17 July 2026
Ref: STP25-2454

**RE: RFI Response/Technical Memorandum
Stormwater - Proposed Warehouse and Food and Drink Outlet at 62 Blunder
Road, Oxley QLD 4075**

STP have prepared this RFI response/Tech Memo in response to an Information Request issued by Brisbane City Council (BCC) dated 3rd July 2026. The responses to the Request for Information (RFI) Items are included in Section 2.0.

Figure 1 –MUSIC Model - Lot 1

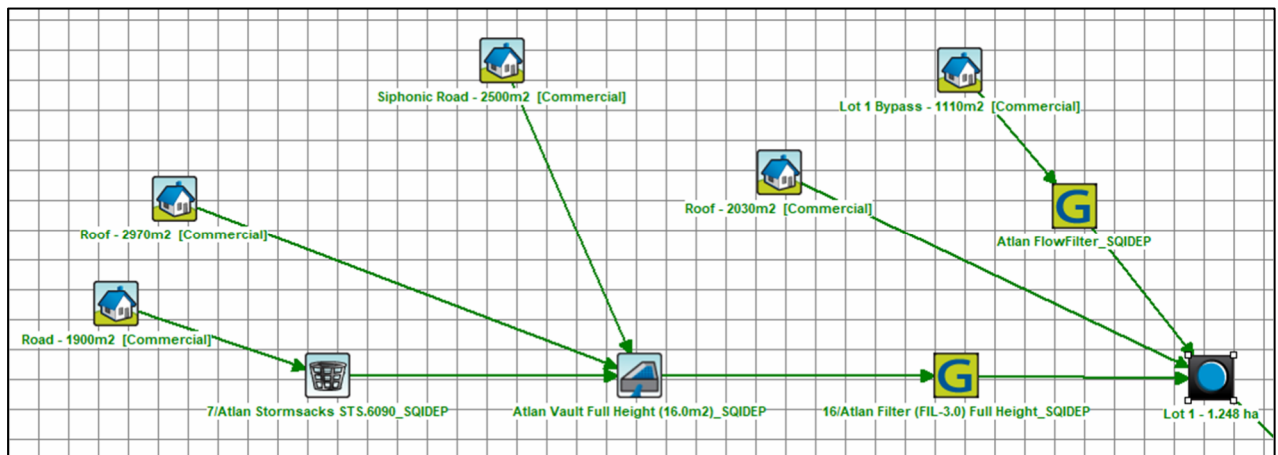
Proposed Lot 1 has been modelled with 7 x Atlan StormSacks and 16 x AtlanFilters. It is proposed to shift the location from the approved southeastern corner to the filled area as requested by BCC officers and continue to discharge to the waterway.

Other changes include incorporating an Atlan FlowGuard system to treat each of the two ramp areas, and allowing a portion of suspended roof area to discharge untreated to the surface below. It is proposed to incorporate scour protection at the surface which will be detailed at the operation works stage. Please refer to Appendix B for the catchment areas and Figures 1 and 2 below for the MUSIC Model and Modelling results.

It is noted the result for TN removal being 44.5% is slightly below the target of 45% however given this is within 0.5% it is considered minor and unlikely to create any actionable nuisance.

Figure 3 - MUSIC Model - Lot 2

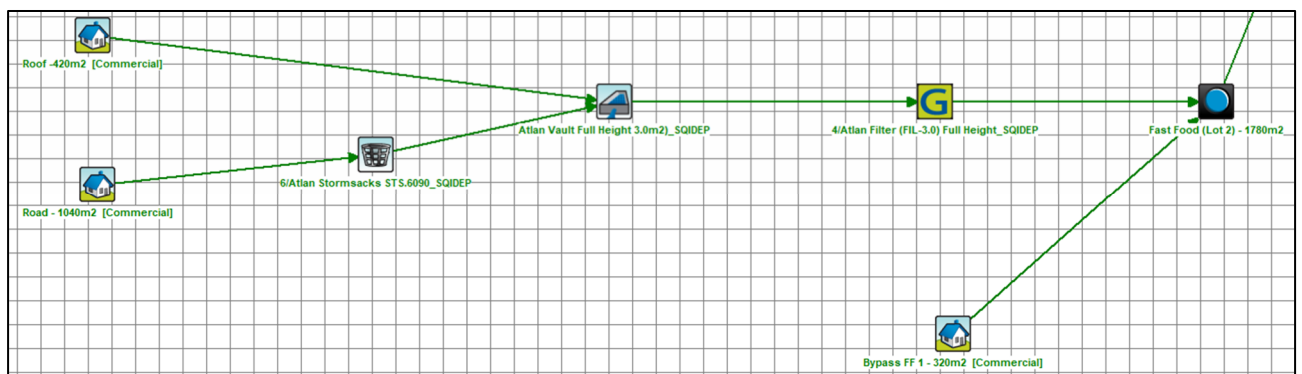
It is proposed for Lot 2 to provide a stormwater treatment system located below ground within Lot 2 and discharge to the waterway. This will ensure the stormwater management system can be managed independently.

This consists of 6 x Atlan StormSacks and 4 x AtlanFilters. Please refer to Figure 3 and 4 below for the MUSIC Model and Modelling results.

Figure 5 - MUSIC Results - Lot 3

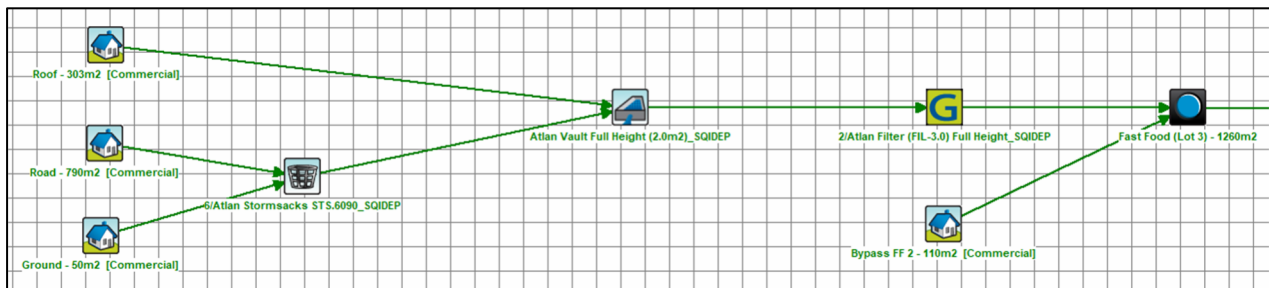
It is proposed for Lot 3 to provide a stormwater treatment system located below ground within the carpark area of Lot 3 and discharge to the waterway. This will ensure the stormwater management system can be managed independently.

Stormwater treatment for Lot 2 consists of 6 x StormSacks and 2 x AtlanFilters. Please refer to Figures 5 and 6 below for the MUSIC Model and Modelling results.

STORMWATER MANAGEMENT
OVERALL LAYOUT

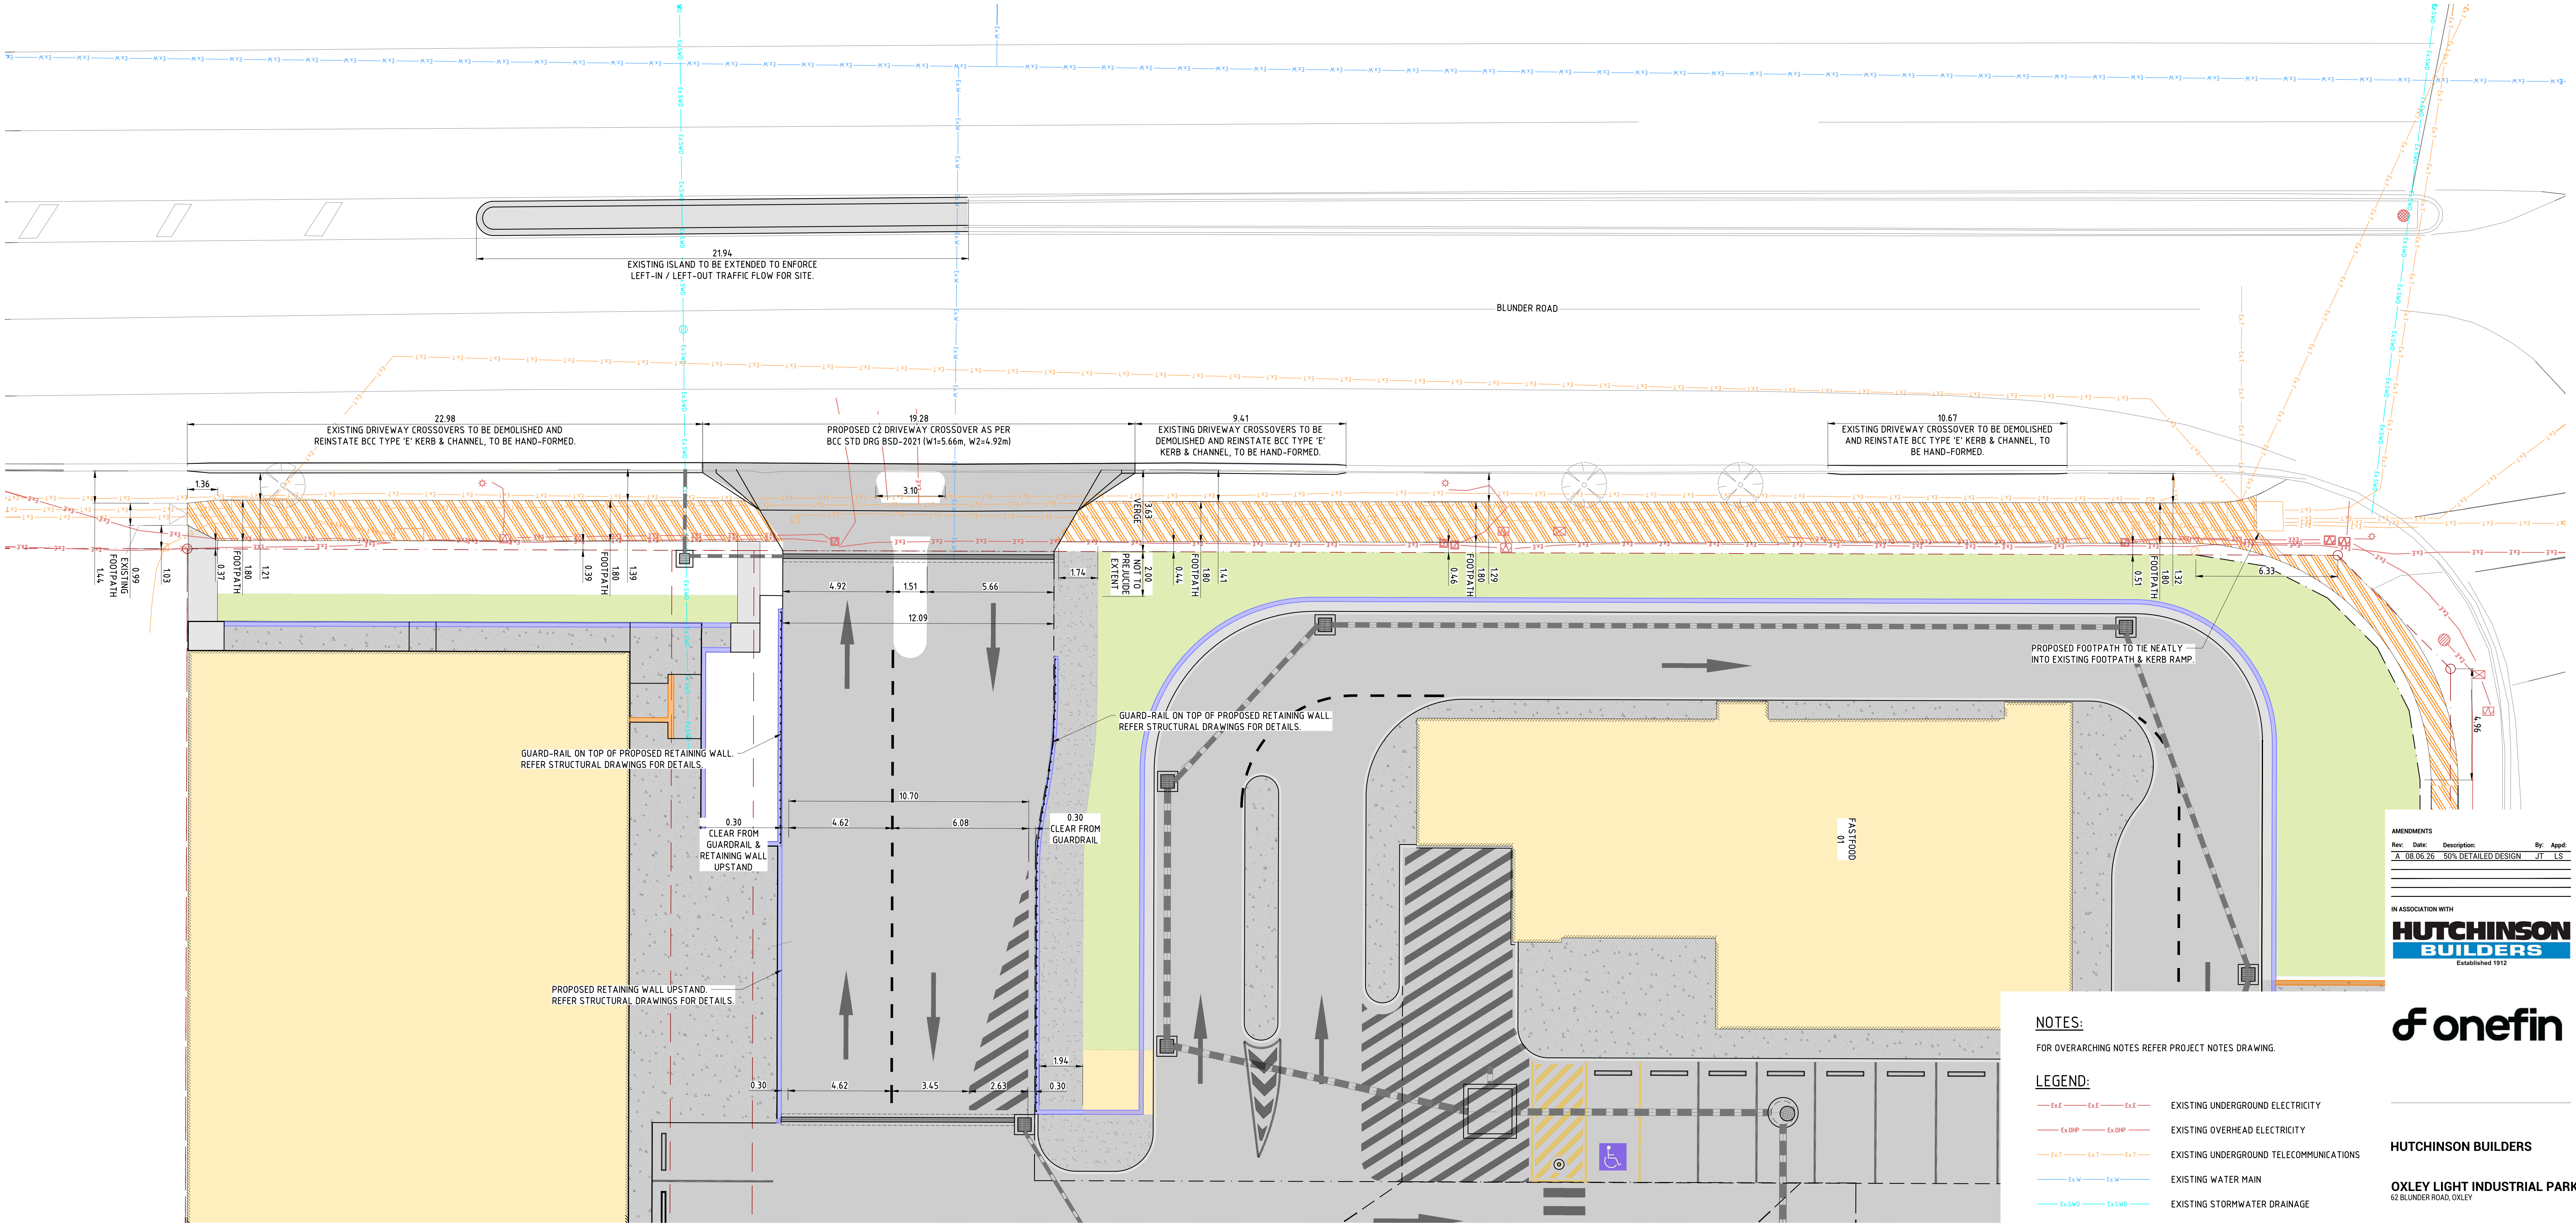
Item 2a: The treatment system has been amended to suit the updated stormwater drainage design. Refer to the STP Civil Stormwater Plans.

Item 2b: This has been shown on the included STP Civil Stormwater Plans.

Item 3: The proposed location of the tank has been moved as requested by BCC officers to the filled area. Refer to STP Civil Stormwater Plans.

PROPOSED FAST FOOD 2 (LOT 3) TREATMENT SYSTEM
1x ATLAN VAULT, CUBE, 1200mm INTERNAL HEIGHT
2x FULL HEIGHT ATLAN FILTER CARTRIDGES

PROPOSED LOT 1 TREATMENT SYSTEM
2x ATLAN VAULTS, RECTANGULAR, 1200mm INTERNAL HEIGHT
16x FULL HEIGHT ATLAN FILTER CARTRIDGES
